March 9, 2016

Subject: **Request for Modification to the Section 404 Individual Permit and Section 401 Water Quality Certification** for the proposed Greensboro Eastern Loop from US 70 Relocation to SR 2303 (Lawndale Drive), Guilford County, Division 7. WBS Element No. 34821.1.1, TIP Nos. U-2525B and U-2525C.

**SHEET 38A1**  
added March 9, 2016

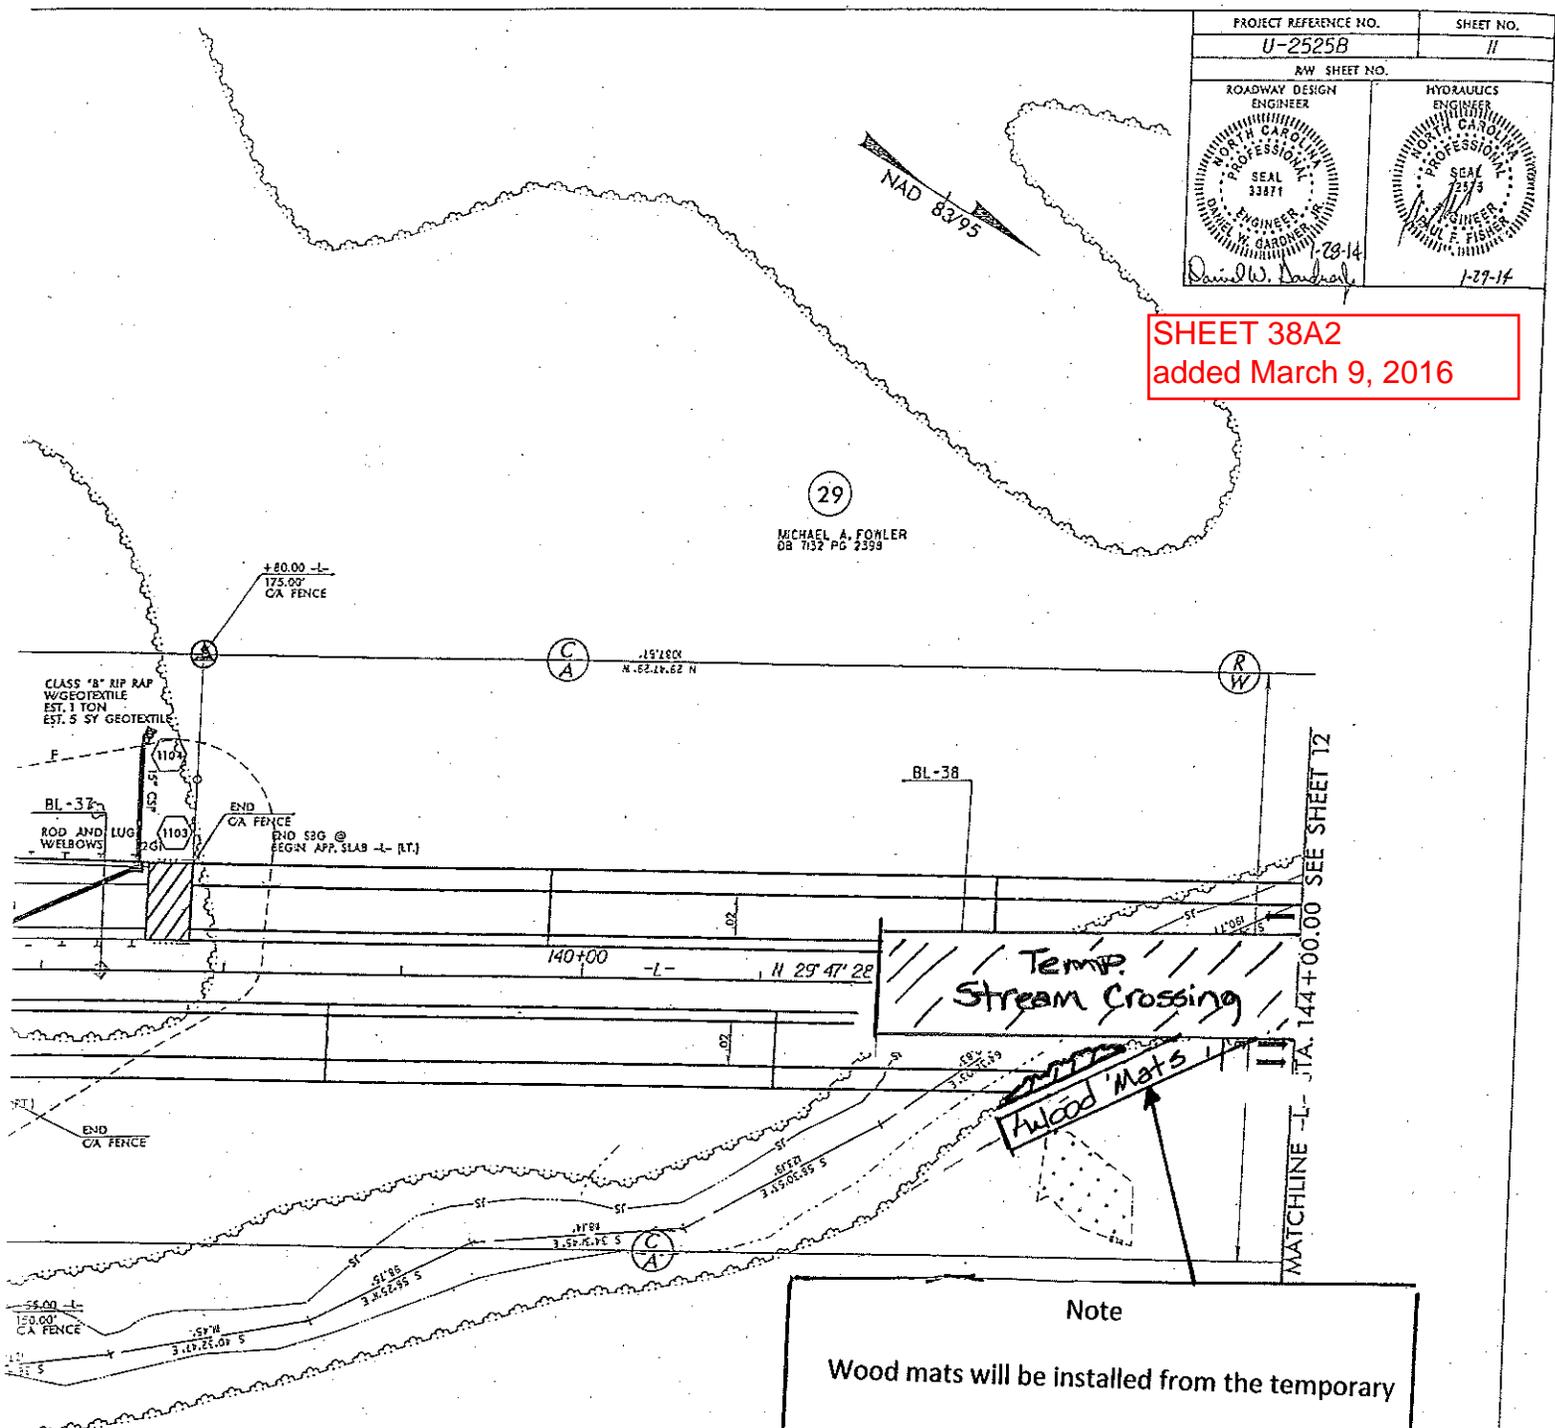
Repair of the bank will involve the placement of Class VII material (at least 50% of rock with diameter of 1.5 to 3 ft, 40% with diameter of 2 inches to 1.5 ft and not more than 10% with less than 2 inches in diameter) placed at a 1.5 to 1.0 slope along the eroded bank. Larger rock will be placed at the bottom to better anchor the project with smaller rock used at the top and to fill in gaps. The height of the riprap from toe of slope will be approximately eleven feet and the linear width along the stream will be 55 linear feet. Heavy machinery will access the proposed area of work from the landward side of the stream through the wetland with no proposed work in the actual stream. Approved temporary matting will be utilized in all portions of the wetland that may be crossed by the heavy machinery with an emphasis on impacting as little of the wetland as possible. At the conclusion of the bank stabilization, a wetland soil and vegetative mix shall be reestablished in the impacted wetland area to return the wetland to pre-existing elevation.
